UWMC-Northwest Major Institution Master Plan (MIMP)

Development Advisory Committee Meeting #8 September 11, 2023

Preliminary Drafts: DAC Comments

Recommended Revisions

1. Campus Access Points

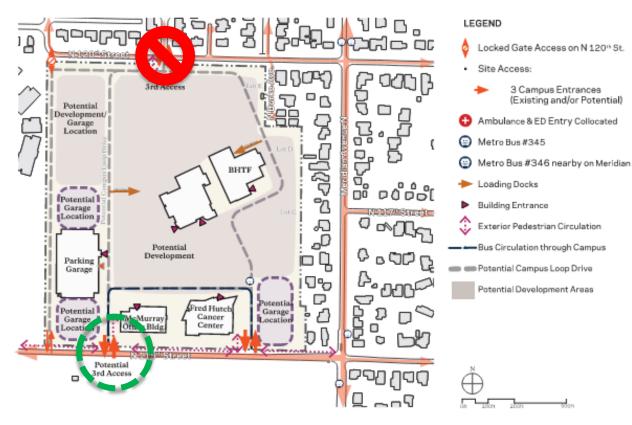
- Recommended Revision: "Prohibiting a new vehicular access point from N 120th Street while maintaining the existing locked access gate for emergency egress, short term construction and deliveries that cannot go under the pedestrian bridge on campus"
- Strong preference from DAC for third campus entry to be placed along N. 115th rather than N. 120th Street.

No Change: Both options will remain for the public Draft MIMP/EIS to obtain full community input. We anticipate identifying a Preferred Alternative in the Final MIMP/EIS.

Height & Setbacks (Items 2,4 and 5)

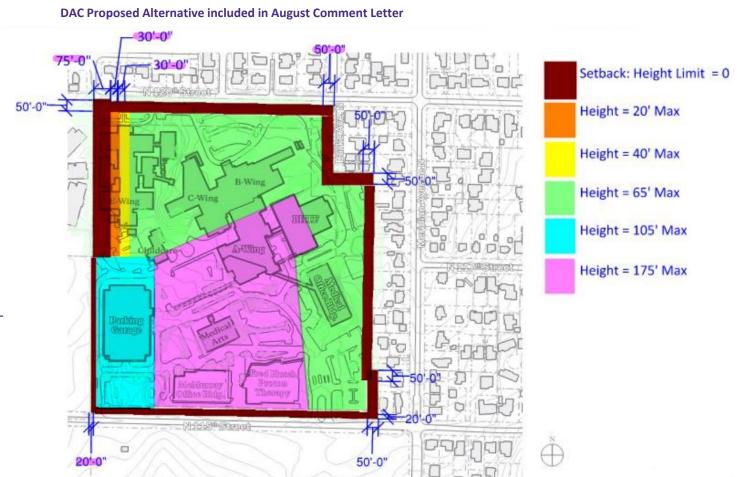
- Recommended Revision: "Locating the tallest structures only near the central or southern areas of the property"
- Recommended Revision: "Restricting building height near residential property lines"
- Recommended Revision: "Increasing the setbacks abutting residential parcels"
- Recommended Revision: "Setbacks may include driveaisles, parking, etc. as long as the existing vegetation remains intact..., except along the west Property Line within the 75'-setback zone. At that location, vehicular traffic must be limited to Fire Lane Only, no other personal or commercial vehicles."
